**CITY OF CHATTANOOGA  
PUBLIC WORKS DEPARTMENT  
ENGINEERING DIVISION**

**ADDENDUM NO. 2  
to the Contract Specifications  
for  
Roof Repair for West 12<sup>th</sup> Street YFD  
Y-16-003-201**

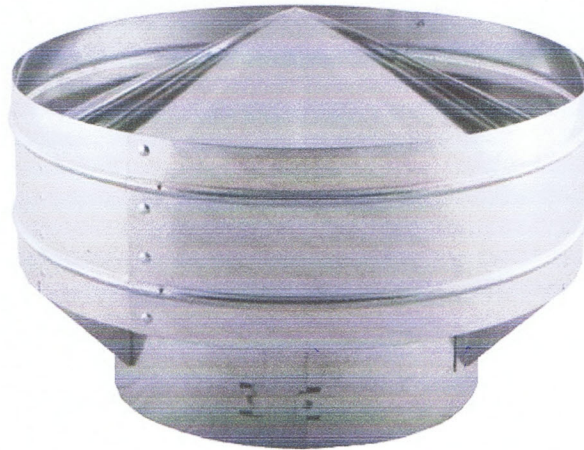
There are 8 existing exhaust hoods on the roof that are in very poor condition.

The replacement of the exhaust hoods/vents to be replaced has been clarified on the attached bid schedule. The replacement hoods are to be 8" galvanized refer to the attached cut sheets for recommended hoods/vents.
